Amendments to the Drawings:

REMARKS

This amendment is submitted in response to the Office Action mailed April 8, 2005. Claims 1-6, 8-15, 17-18 and 20 remain in this application. Claims 7 and 16 are cancelled by this amendment. Claim 19 is cancelled in this response as a result of a restriction requirement.

FIG. 3

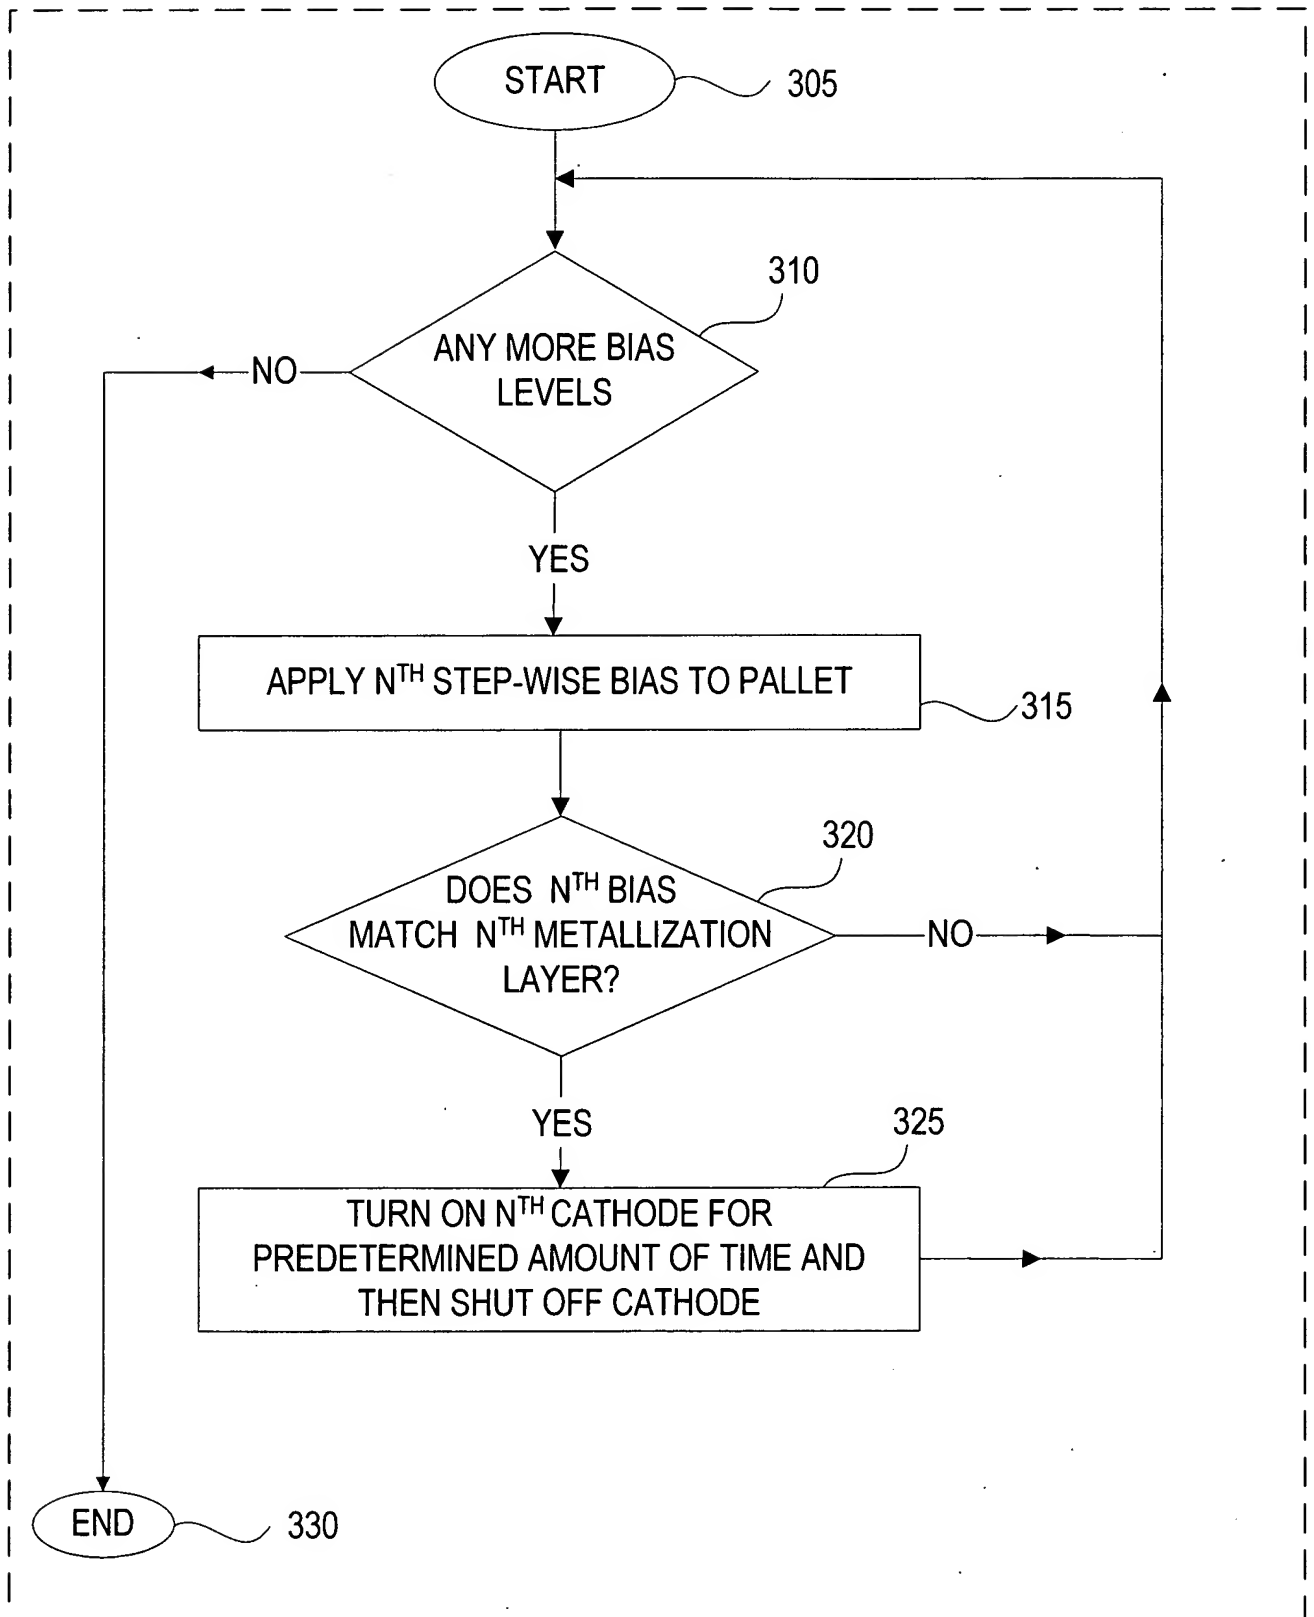
In the Office Action the Examiner objected to the drawings as failing to comply with 37 CFR 1.84(p)(5) because they do not include the following reference sign(s) mentioned in the description: 170 [0008]; 305, 310, 315, 320, 325, and 330 [0031]; and 430 [0035]. The Applicant has amended paragraph [0008] to eliminate 170, amended

The attached sheet of drawings includes changes to Fig. 3. This sheet, which includes Fig. 3, replaces the original sheet including Fig. 3. In Fig. 3, wrongly numbered elements have been renumbered as 305, 310, 315, 320, 325, and 330.

figure 3 to include the proper reference signs 305, 310, 315, 320, 325, 330, and amended paragraph [0035] to correct the reference to 430.
